ADDENDUM# 6

UK Level B Support Services BP-2
ADDENDUM No. 6
CCK-2655-23
10/11/2022

BP-2_ADDENDUM NO. 6

Subject: Renovate/Upgrade UK Healthcare Facilities
Pavilion A Level B Support Services Renovation
UK # 2239.77

LEVEL B DIMENSION PLAN - AREA A PHASE 3

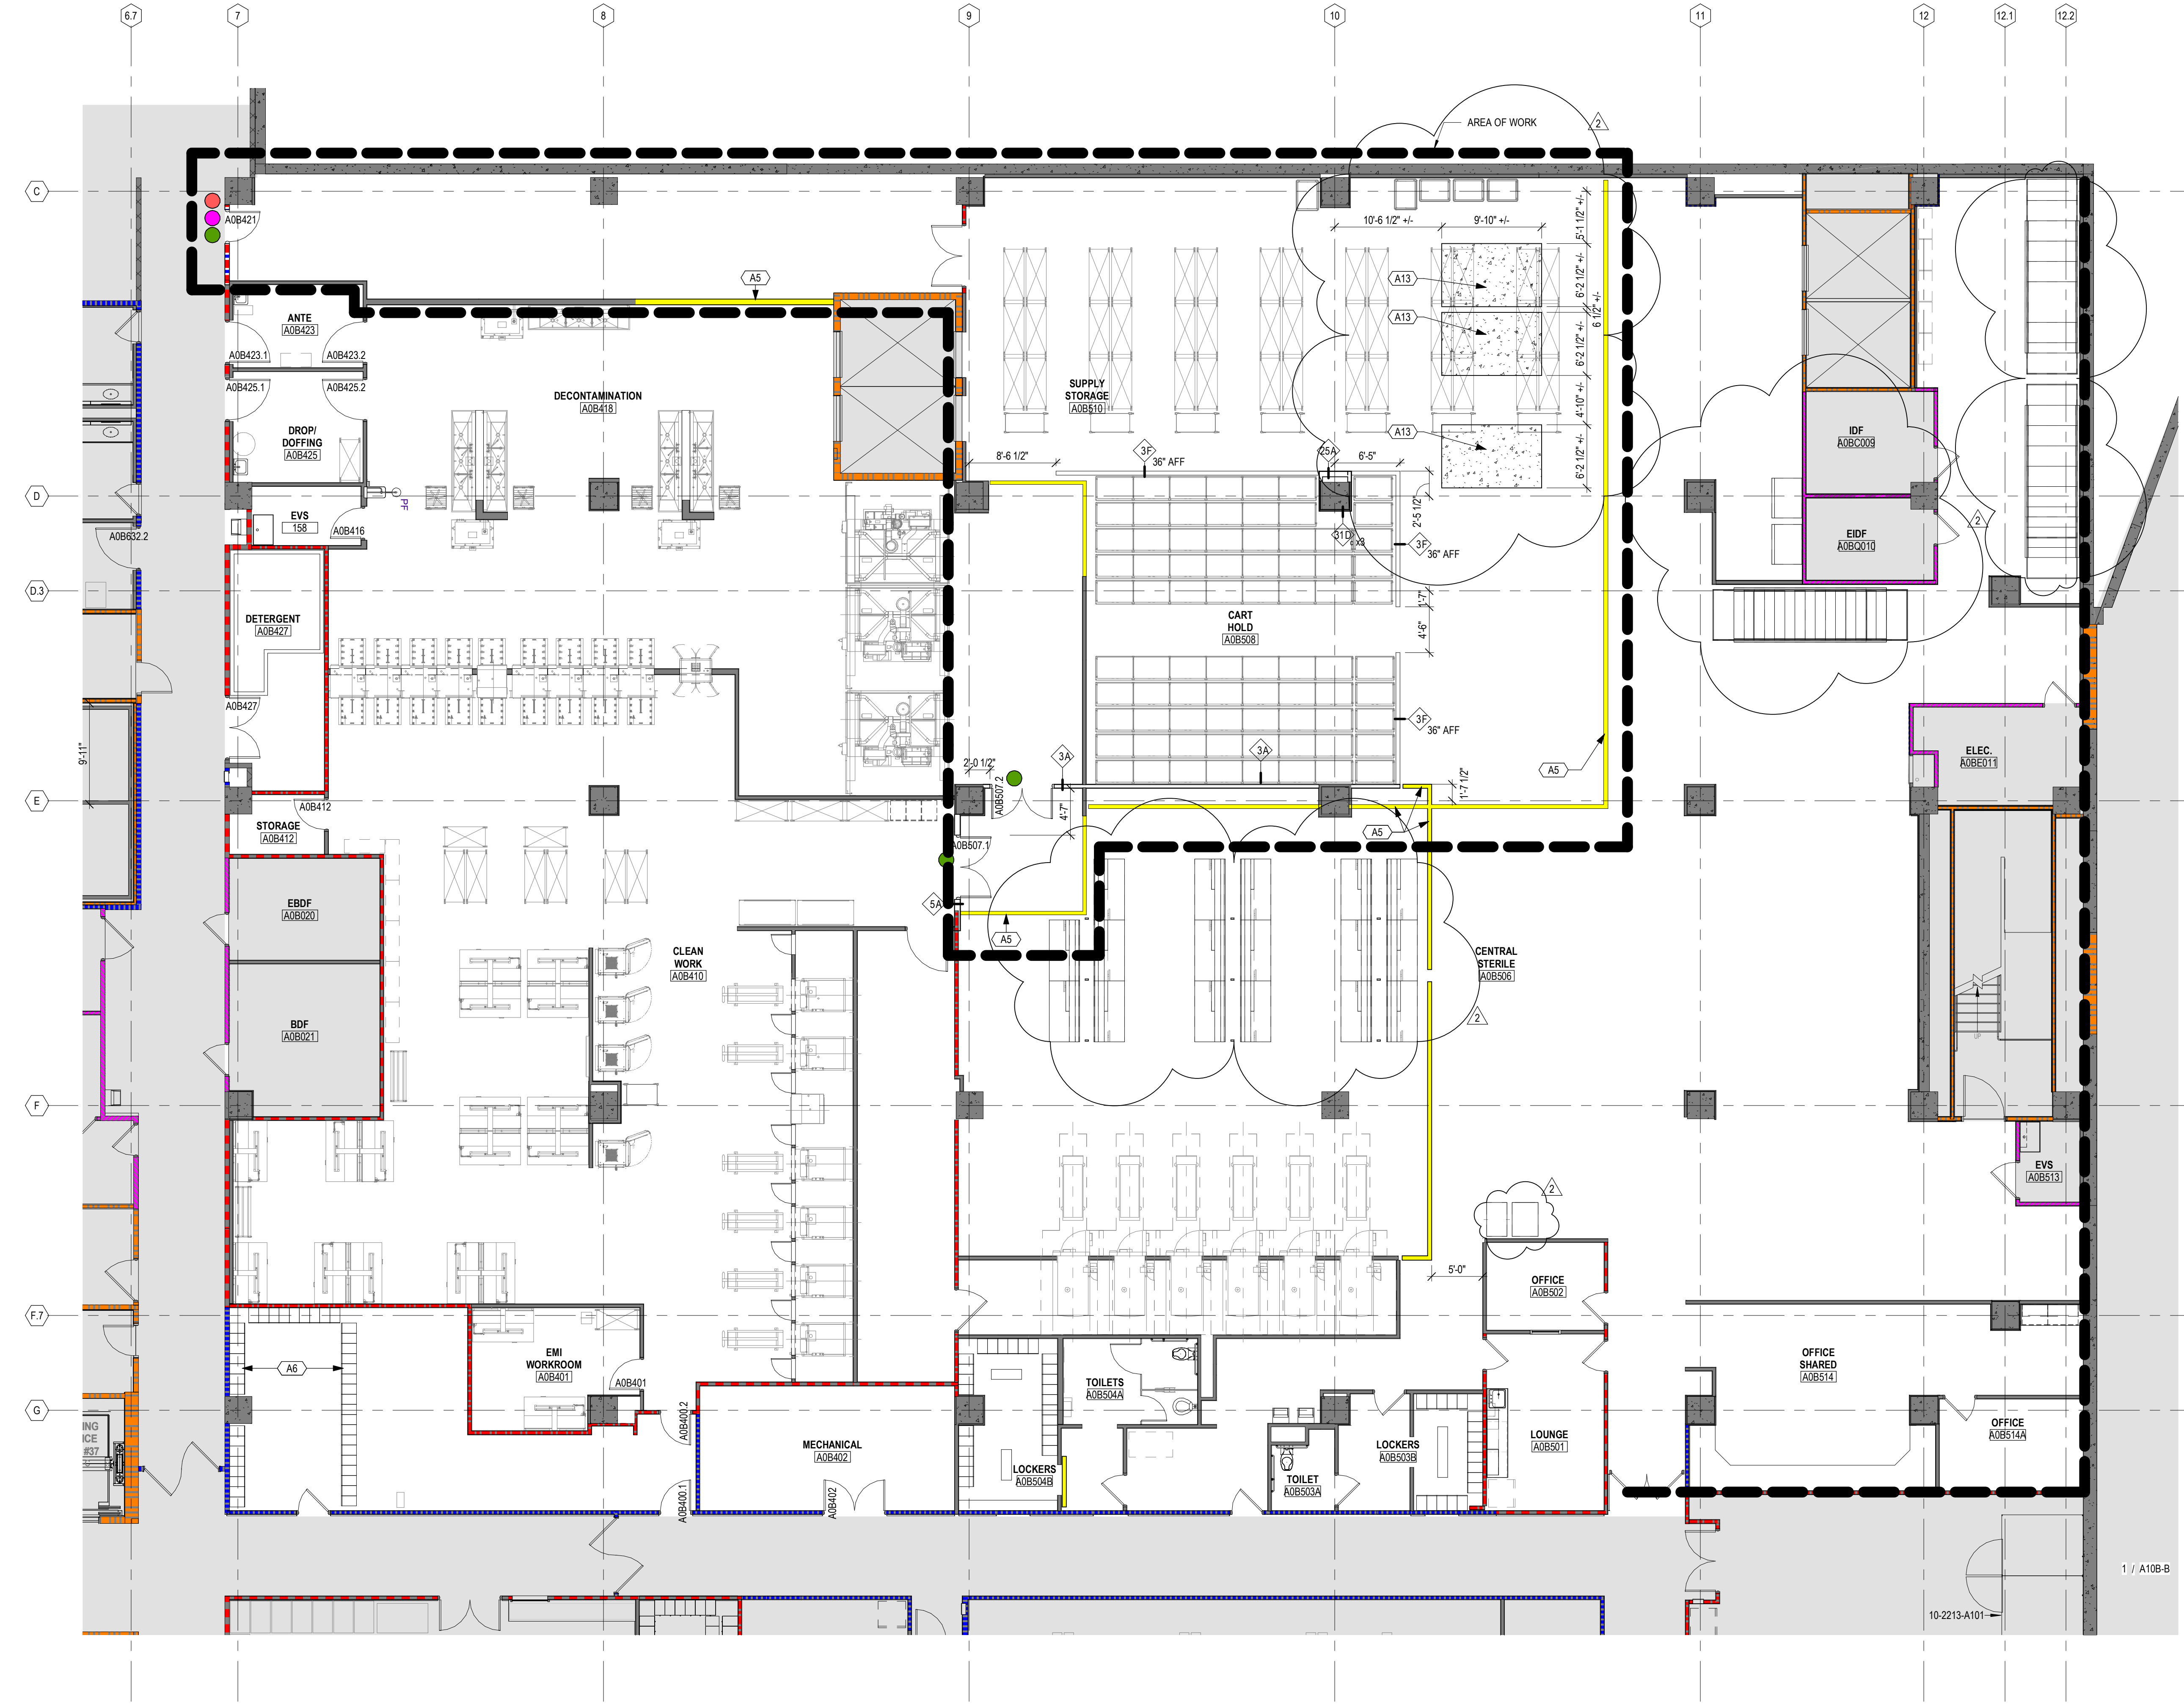
- Item No. 04** Re: Form of Proposal TC-209, General Trades, Attachment B, add item 17.c. to this contractor's scope of work.
- c) Include Note A13 on A10B-A.3 pertaining to concrete in-fill of existing recessed slab. (ADD #6)

- A. See clouded areas and reference numbers in door schedule
- 2.10 Sheet A10B-A.3 LEVEL B DIMENSION PLAN – AREA A PHASE 2**
 - A. See clouded areas and reference numbers in door schedule

- A5 TEMPORARY WALL SHOWN FOR REFERENCE. CM TO CONTROL TEMPORARY BARRIER LOCATIONS. WORK BY GENERAL TRADES.
- A6 TEMPORARY LOCKERS
- A13 EXISTING 8" SLAB RECESS. FIELD VERIFY TOP OF EXISTING SLAB RECESS PERIMETER STEEL ANGLE IS FLUSH WITH SURROUNDING SLAB AREA. IF EDGE ANGLE IS NOT FLUSH NOTIFY ARCHITECT FOR DIRECTION. PERMANENTLY CAP DRAINS WITHIN SLAB RECESS. INFILL RECESSED AREA TO HAVE FLUSH FINISHED SURFACE WITH TYPICAL SURROUNDING SLAB AREA. INFILL SHALL BE 4000 PSI CONCRETE SLAB REINFORCED WITH #3@8" ON CENTER EACH WAY. REINFORCEMENT SHALL BE CHAIRED IN PLACE AT 1" CLEAR FROM TOP OF SLAB. PRIOR TO PLACING SLAB, CLEAN EXISTING SURFACES TO BE BONDED WITH FRESH CONCRETE AND COAT WITH A BONDING AGENT (ASTM C 1099 TYPE II). TOOL JOINT AROUND SLAB PERIMETER, AT INTERFACE WITH EXISTING PIT EDGE ANGLE TO CREATE A 1/2" WIDE X 1/2" DEEP JOINT AROUND THE NEW INFILL SLAB. FILL JOINT WITH A SEMI-RIGID JOINT FILLER AFTER CONCRETE HAS FULLY CURED (TWO-COMPONENT WITH A TYPE A SHORE DUROMETER HARDNESS OF 90 MINIMUM ACCORDING TO ASTM D 2240). TRIM JOINT FILLER TO CREATE FLUSH TOP SURFACE TRANSITION.

LEVEL B DIMENSION PLAN - AREA A PHASE 4

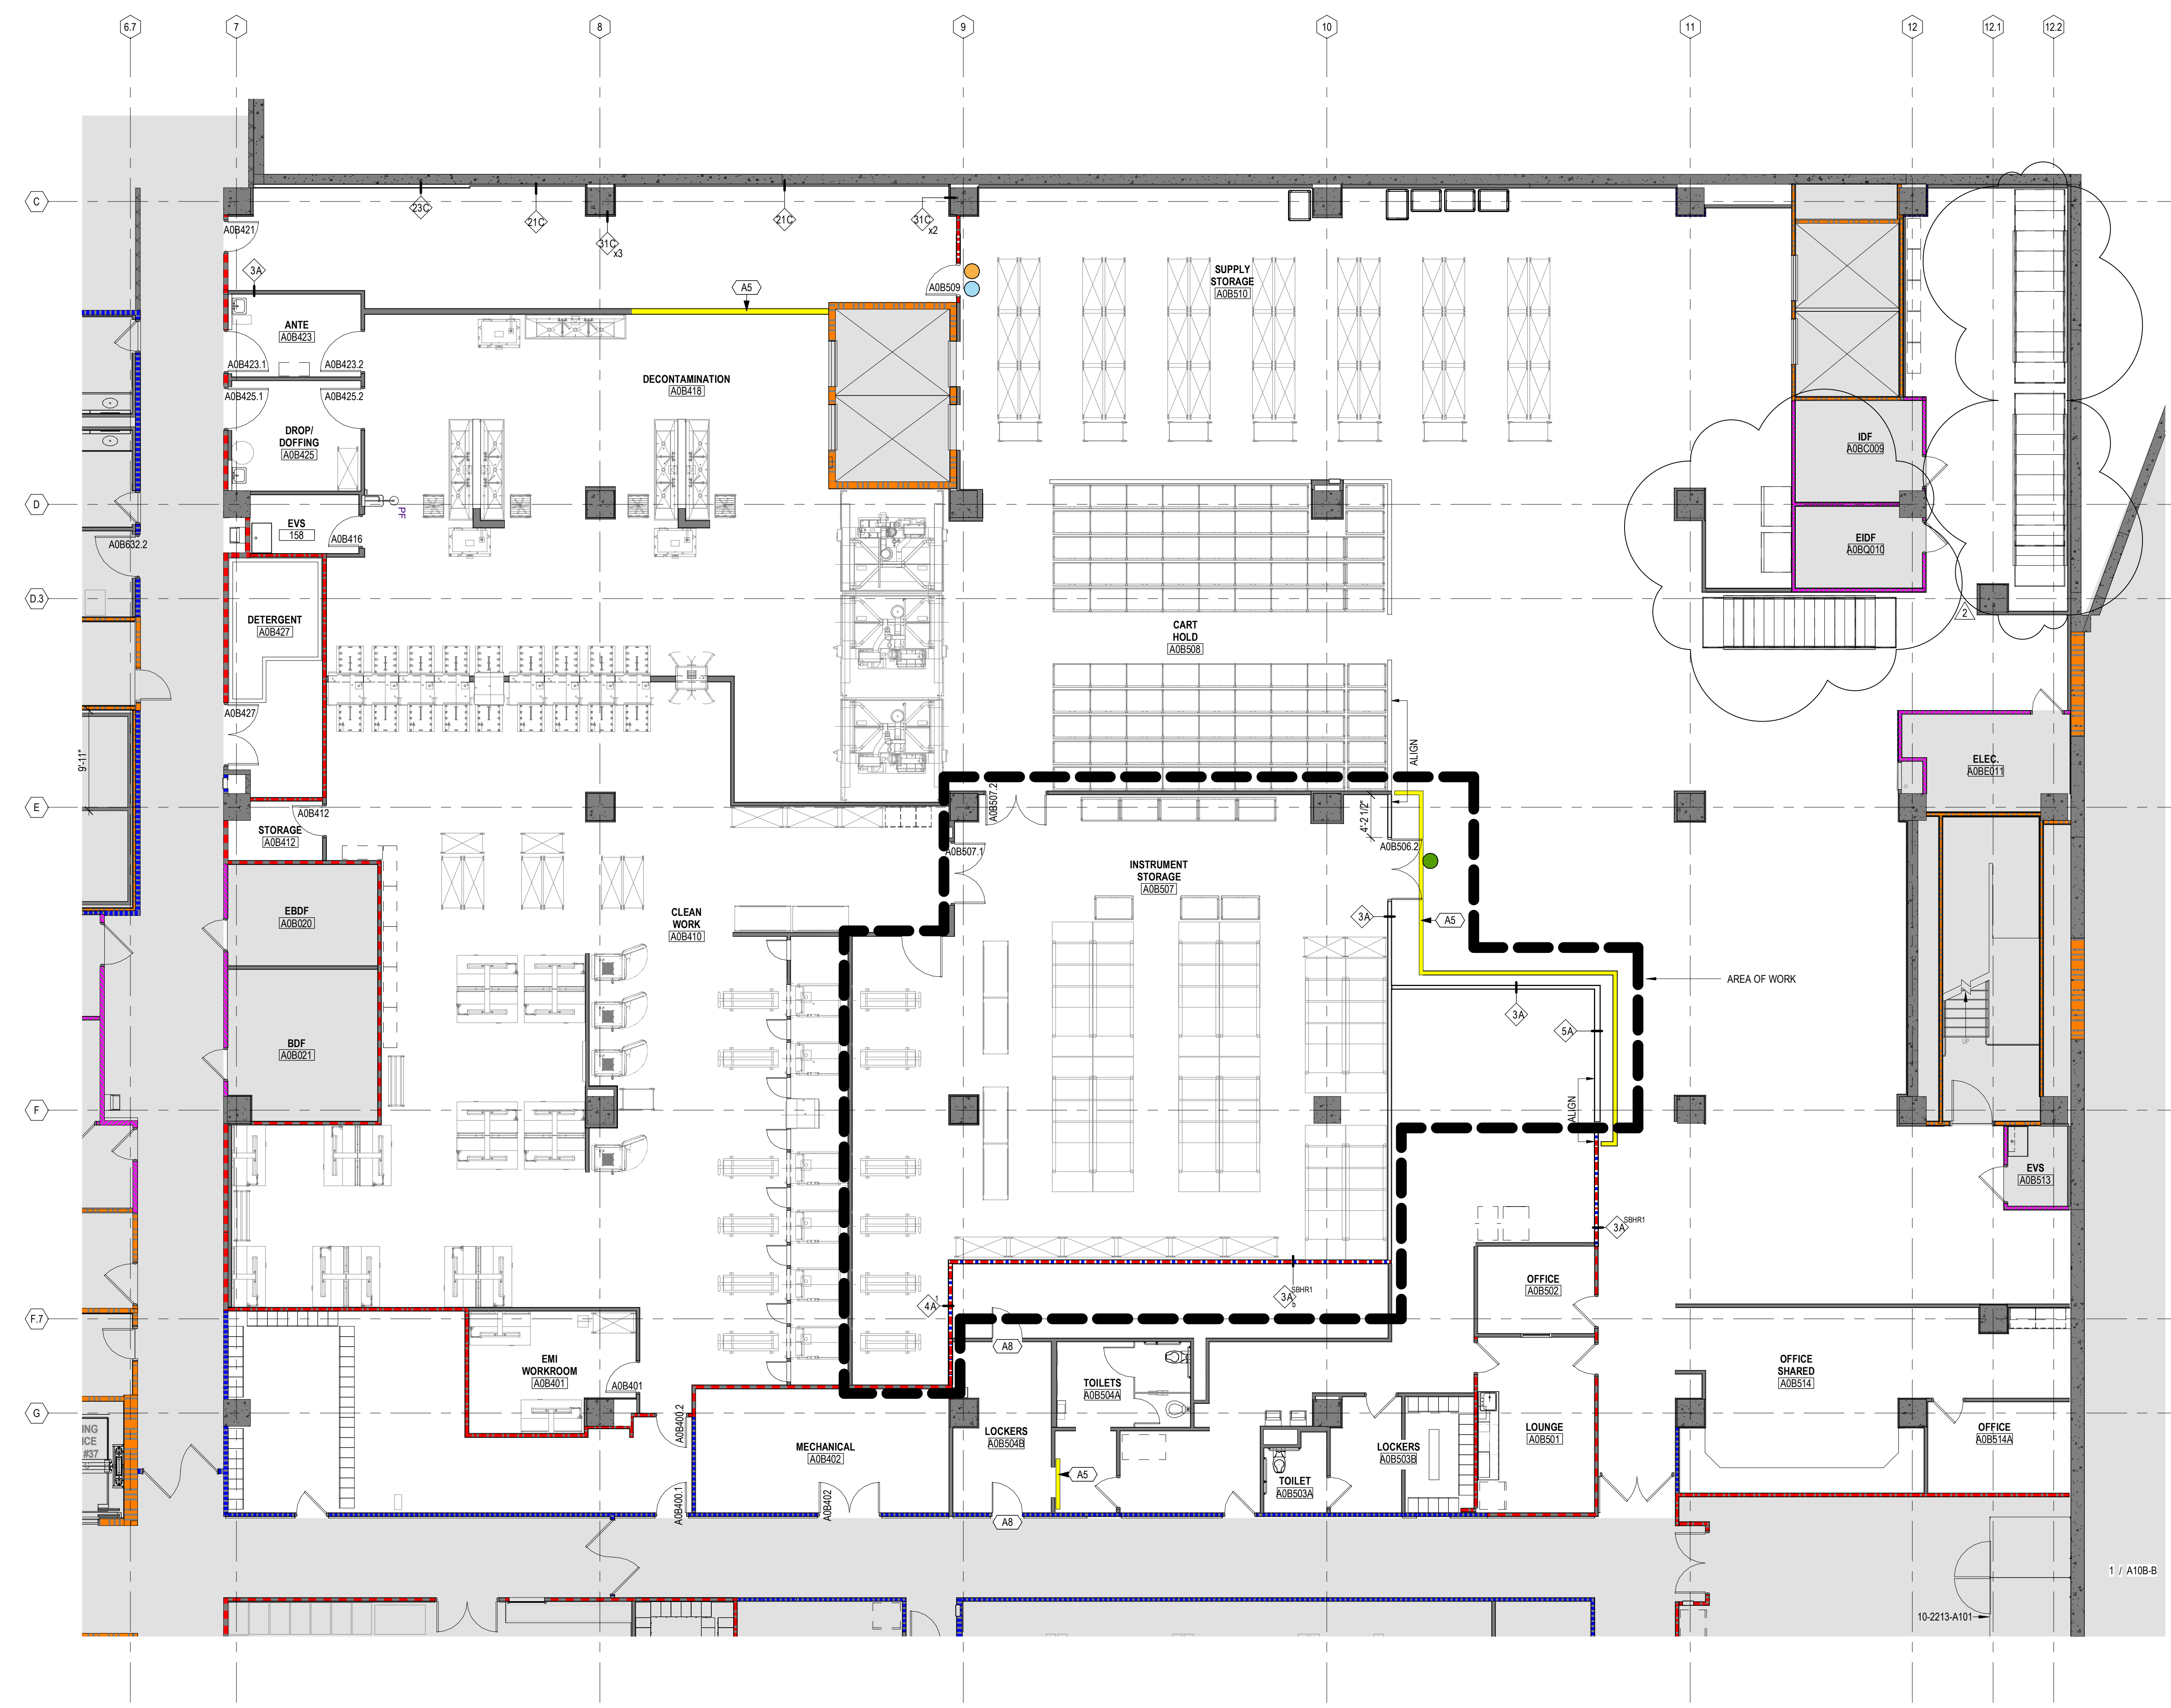
- 2.11 Sheet A10B-A.4 LEVEL B DIMENSION PLAN – AREA A PHASE 2**
 - A. See clouded areas and reference numbers in door schedule
- 2.12 Sheet A803 – FM ADMIN – ENLARGED PLANS AND ELEVATIONS**
